EQUIPMENT/FURNISHINGS - GLOVE BOX/MAP CASE LATCH ASSEMBLY REPLACEMENT

MODEL	SERIAL NUMBERS
172R	17280001 thru 17281622
172S	172S8001 thru 172S12684
182T	18280001 thru 18283147
T182T	T18208001 thru T18209100
206H	20608001 thru 20609100
T206H	T20608001 thru T20609641

SEB-25-06  
Page 1 of 6

Figure 1. Latch Assembly Installation (Sheet 1)

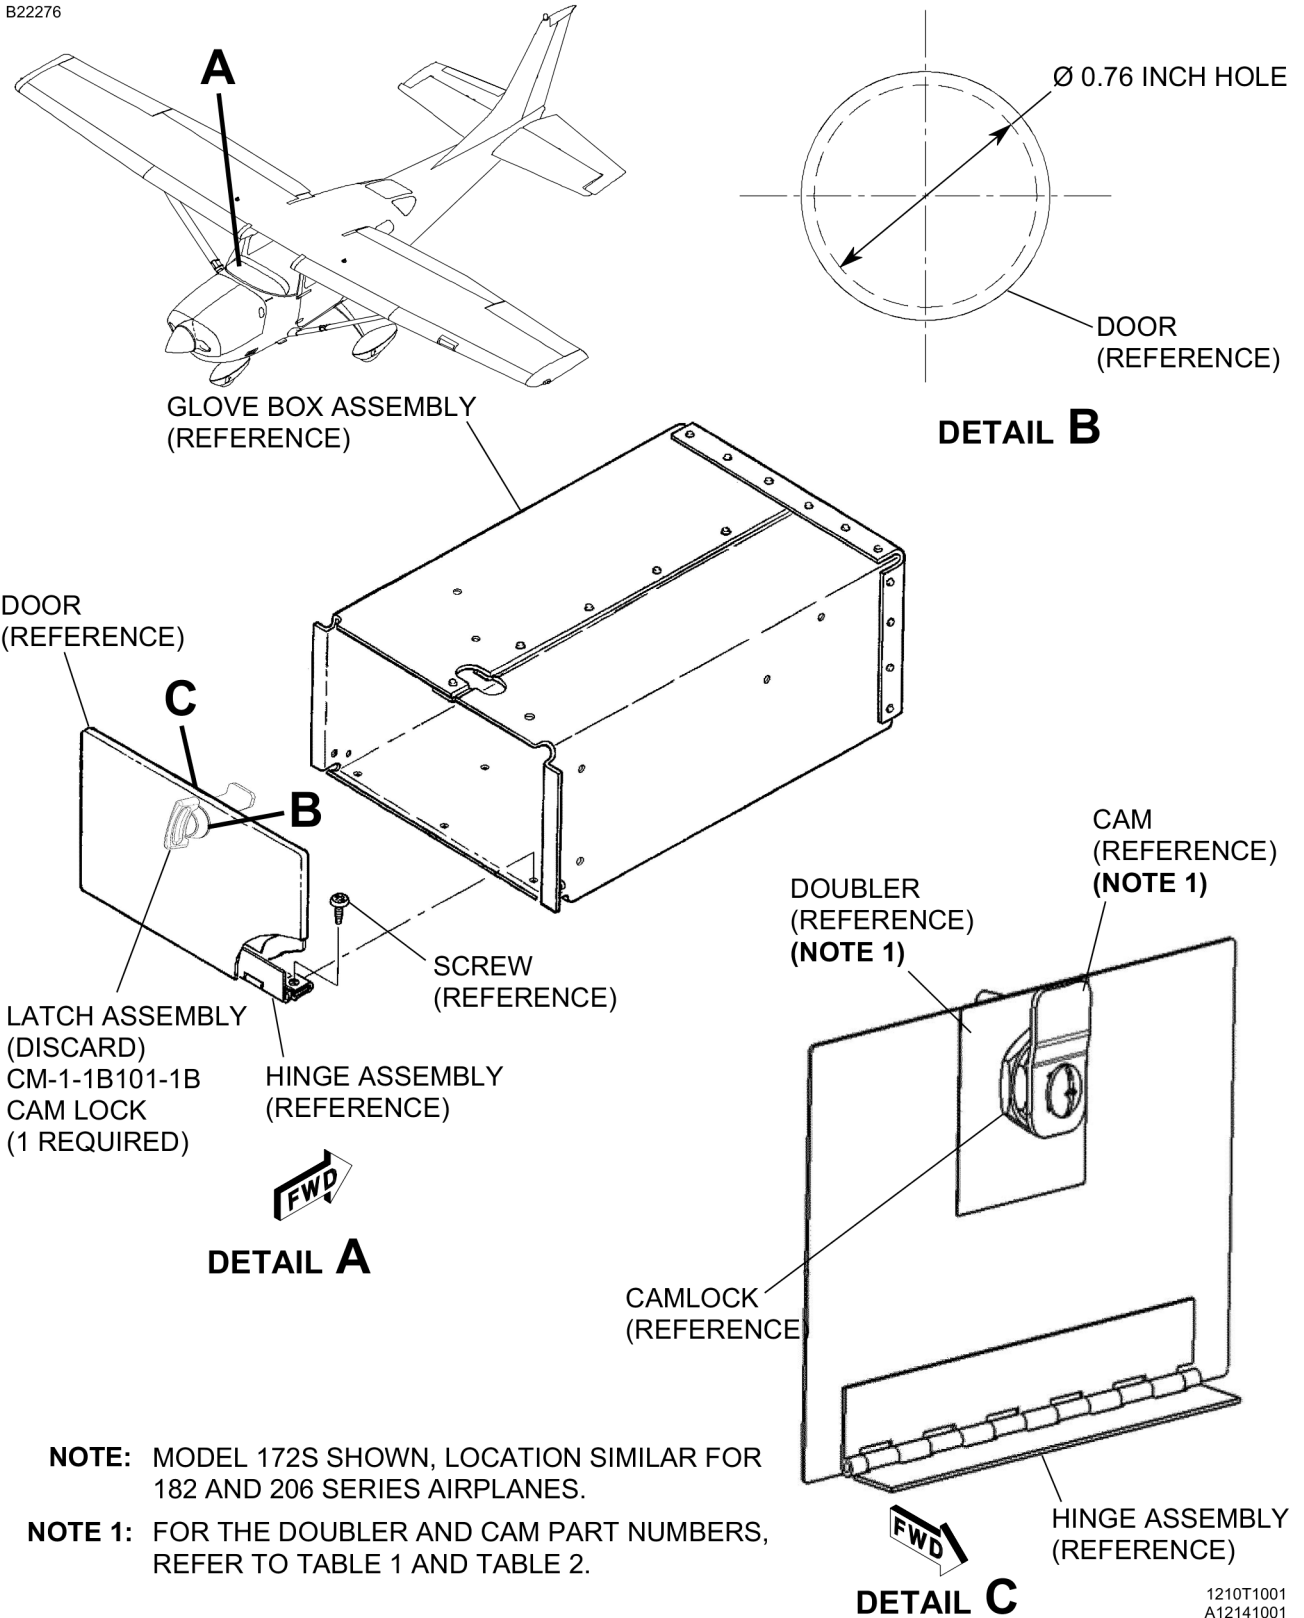
5. (Refer to Figure 1.) Remove and discard the HPL3-4-1 Latch Assembly from the glove box door.
6. Ream the glove box door hole to 0.76 Inch diameter concentric to the old hole.

9. Install the CM-1-1B101-1B Camlock to the glove box door.

**NOTE:** The black plastic sealing washer goes under the handle on the outside of the door.

10. Install the cam that was ordered with the screw from the camlock.
  - A. Permissible to hand form as required to fit installation. Use heat (such as from a heat gun or similar) as required.

**NOTE 1:** FOR THE DOUBLER AND CAM PART NUMBERS, REFER TO TABLE 1 AND TABLE 2.
